# Access Compliance Report

## Public Rights-of-Way

### (Curb Ramps)

Intersection ID: 46697	Main Street: GOLDFIELDS_DR	Cross Street: COFFEEBERRY_LN	Location: NE
ADA ID: 3D4EDE59AFA7	Ramp Type: PerpDiag	Initial Pass/Fail: Fail	Overall Compliance: No
Severity Score: 22.5			
Codes/Mitigation Info/Possible Solution		Field Measurements/Component Compliance

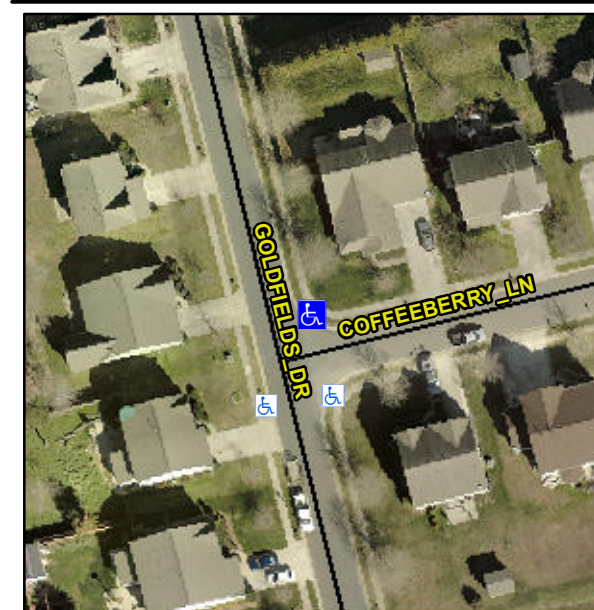
**Not Found, R304.5.1, R304.2.2, R304.5.3**

Compliance	Description	Data	Compliance	Description	Data
N/A	Ramp Length (in)	46.0	No	Ramp Slope (%)	8.4
No	Ramp Width (in)	47.0	No	Ramp XSlope (%)	2.6
N/A	Flare Type LT	N/A	N/A	Flare Type RT	N/A
N/A	Flare Slope LT (%)	N/A	N/A	Flare Slope RT (%)	N/A
N/A	Flare Traversable LT?	N/A	N/A	Flare Traversable RT?	N/A
N/A	Landing Length (in)	N/A	N/A	DWS Provided?	N/A
N/A	Landing Width (in)	N/A	N/A	DWS Contrast?	N/A
N/A	Landing Slope (%)	N/A	N/A	DWS Length (in)	N/A
N/A	Landing X Slope (%)	N/A	N/A	DWS Full Width?	N/A
N/A	Landing Curb? (Y/N)	N/A	N/A	DWS Offset (in)	N/A
N/A	Shared Landing?	N/A			
N/A	Gutter Ponding?	N/A	N/A	Gutter Slope (%)	N/A
N/A	Gutter Lip Ht (in)	N/A	N/A	Gutter X Slope (%)	N/A
N/A	Painted X Walk1?	No	N/A	Painted X Walk2?	No
	X Walk 1 Direction	To W		X Walk 2 Direction	To S
N/A	X Walk 1 Width (in)	N/A	N/A	X Walk 2 Width (in)	N/A
	X Walk 1 Slope (%)	0.2		X Walk 2 Slope (%)	3.3
	X Walk 1 X Slope (%)	2.9		X Walk 2 X Slope (%)	0.8

**Remove & Replace Curb Ramp With Two New Directional Ramps or Equivalent.**
